**STAFF REPORT: JUNE 14, 2023 MEETING**

**APPLICATION NUMBER: 23-8404**

**ADDRESS: 8022 KERCHEVAL**

**SCOPE: REHABILITATE HOUSE, ALTER LANDSCAPE**

VIEW FROM REAR ALLEY

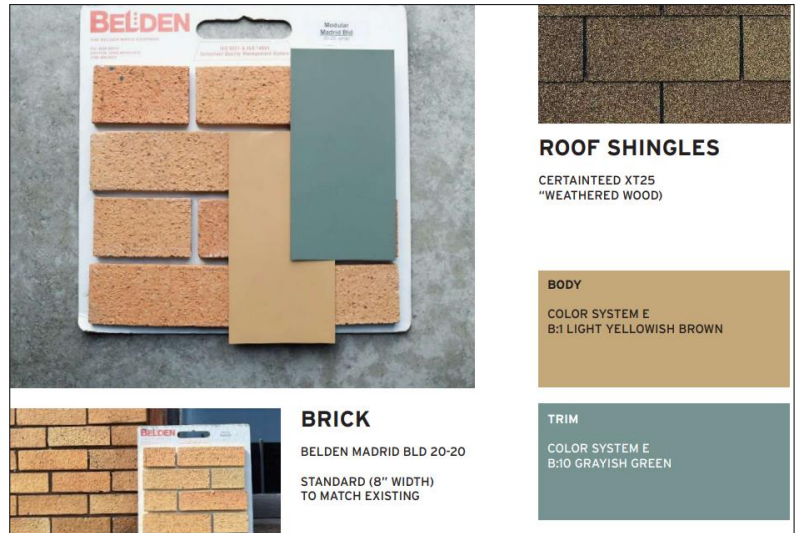
- According to the applicant’s drawings, the erection of a dormer on the east elevation near the rear will allow stair access to the third floor which is to become additional living space. The proposed dormer will not remove character defining details of the historic structure. The proportion of the new gable is narrower than the historic gables, and its detailing: sitting above the roof line with a gable roof (but not an enclosed pediment) retains a similar triangular form but with less detailing, which may let it read as a contemporary element. The applicant selected the color B:1, light yellowish brown for the wood clapboard siding.

- A single skylight is proposed in the same location on the east and west roofs. A cut sheet hasn’t been submitted to confirm the exact dimensions, profile, color/finish and extension distance from the roof. However, the location and size, as shown on the elevation, won’t destroy historic materials that characterize the property, nor create a dominate feature on the structure. The west skylight won’t be visible due to the adjacent structure and the east skylight will be minimally visible due to the depth of the building and the large gable near the front elevation.

- The wheelchair lift proposed at the rear elevation won’t impact the features and spaces that characterize the property. The rendering shows the concrete block with an unfinished surface, so staff recommends it be painted the same paint color proposed for the new dormer.

- The concrete block enclosing the wheelchair lift will be painted to match the color selected for the lap siding.
- A cut sheet of the proposed skylights, which lists all details, dimensions and finish, will be submitted for staff review.
- A cut sheet of the selected exhaust vent shall be submitted for staff review that offers a picture of its exterior appearance, in addition to the details, dimensions and finish of the product. Revised elevation drawings will be submitted for staff review should the selected vent require modifications to the existing opening.

### Removal of historic brick at front elevation

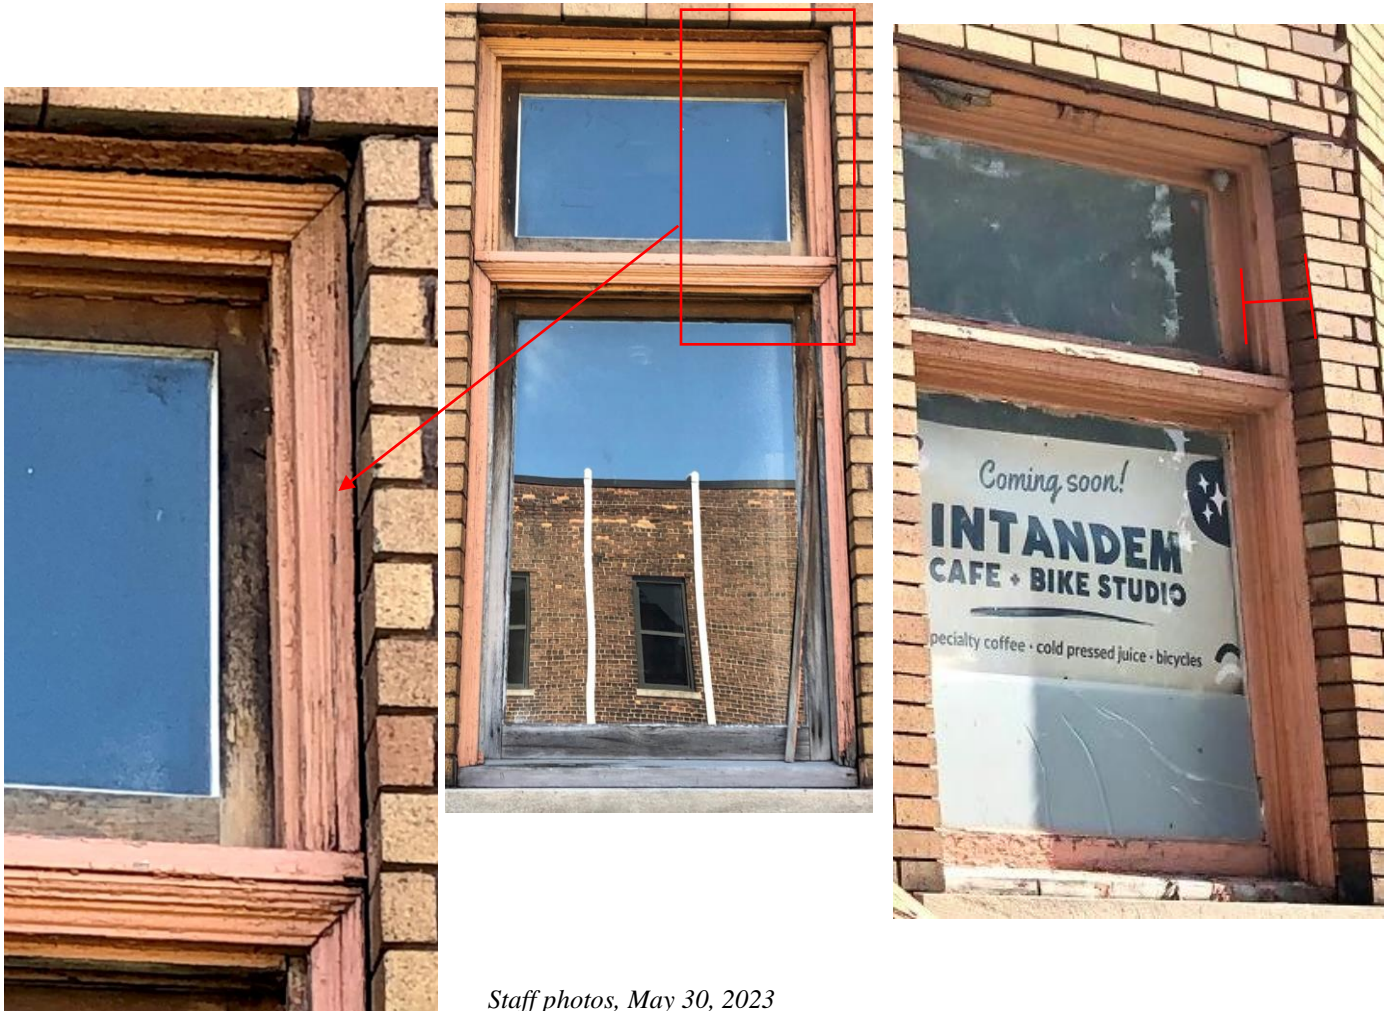
- Staff questioned the need to remove the historic brick veneer from the front elevation and the laying of new brick due to deteriorated masonry anchors. Staff inquired as to whether replacement masonry ties or anchors can be installed to reattach most of the existing bricks to the structure. Staff's reasons for retaining the existing brick facade are:

- This structure doesn't have articulated corners (such as quoins or wood/stone pilasters), so the bricks wrap the corners of the building. Laying new brick on the front elevation to seamlessly fit into the existing condition would be challenging. The new brick would need to be identical in all details to the historic brick – a comparison of dimensions (including depth of each brick) hasn't been submitted.

- The historic brick has a patina due to its age and exposure to weather and other elements; the new, brighter brick would create a distracting contrast against the historic structure.

- The bay's angled corners have a unique break to them which may also be difficult to duplicate.
  - The brick and its method of installation, including the different mortar joint applications and broken corners at the bays are distinctive character-defining features of the structure.

- Replacing the historic brick on the front elevation with new brick will drastically alter the appearance and features of the structure, due to the loss of patina and the subsequent contrast between old and new brick. Additionally, it is not known if the new brick offers an identical dimensional product to seamlessly fit within the existing brick pattern and mortar joints.

Comparison of existing to new

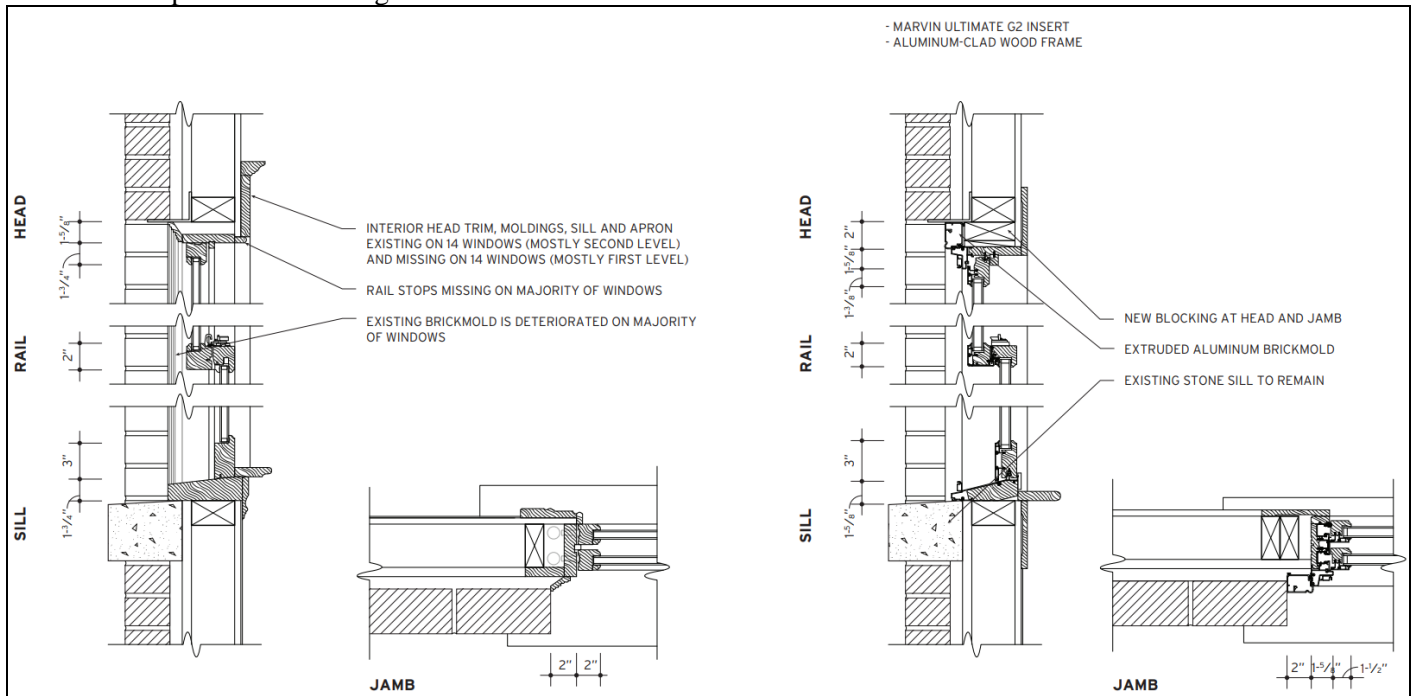
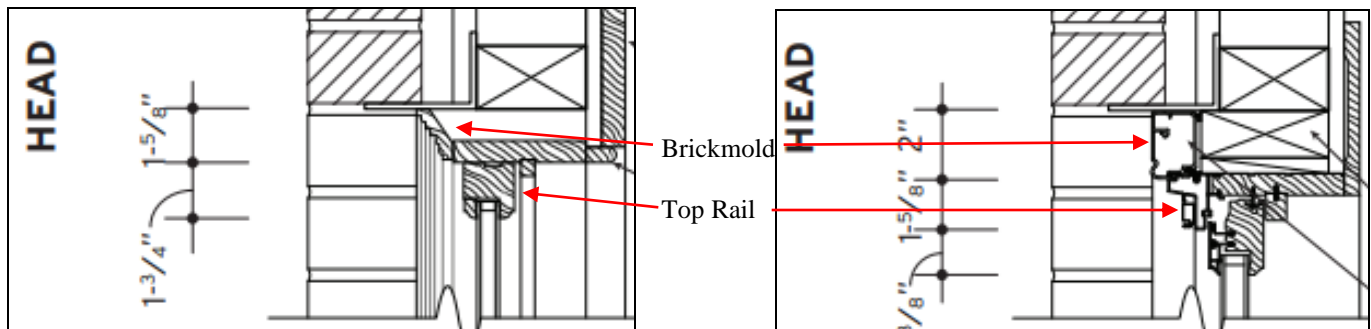
- The most drastic increases in dimensions for the new window are with the brickmold (3/8" taller) and top rail (1-1/4" taller).
- The manufacturer's section shows a standard brickmold with only one small bend, so it has a mostly flat appearance, which is drastically different from the highly detailed existing brickmold. Although the applicant is working with the manufacturer to design a more detailed brickmold, staff is unsure if aluminum can be bent in such a way to match the existing profile and retain adequate strength.

- The existing wood windows are set deeply within the openings, and the wide brickmold has an exceptionally detailed profile. Replacement windows and aluminum brickmold will not offer the same dimensionality and placement.

Alteration to first story front bay windows

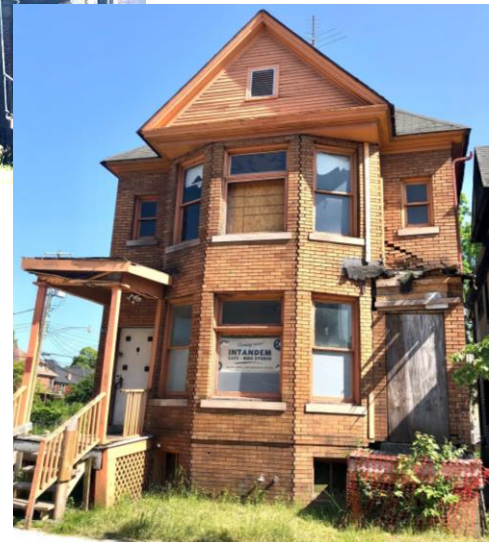
- The two family house was designed as a cohesive structure. Patterning is found in the symmetrical window openings, horizontal raked mortar joints, water table, and decorative brick, all of which is found on each side of the building.
- The two-story bay windows are distinctive character-defining features; the uniformity and relationship between the bay window openings on each floor and elevation is an important historic component of the structure and offers a visual clue as to its original multi-family residential use and era of construction.

- Standard 1 “A property shall be used for its historic purpose or be placed in a new use that requires minimal change to the defining characteristics of the building and its site and environment”, and Standard 2 “The historic character of a property shall be retained and preserved. The removal of historic materials or alteration of features and spaces that characterize a property shall be avoided”, relate directly to the importance of retaining the historic and architectural features, regardless of the property’s current use. The contemporizing of the front elevation with plate glass “storefront” windows is in direct conflict with these standards. As staff stated earlier, the erection of a front deck, offering dining area for the restaurant is a less invasive way to offer support for the new use. The deck can be removed without permanent change to the historic structure.

- The two-story bay windows are distinctive character-defining features; the uniformity and relationship between the window openings on each floor and elevation is an important architectural component of the structure. The installation of storefront glass in the front elevation first floor bay windows would disrupt and alter the symmetry of these window openings.
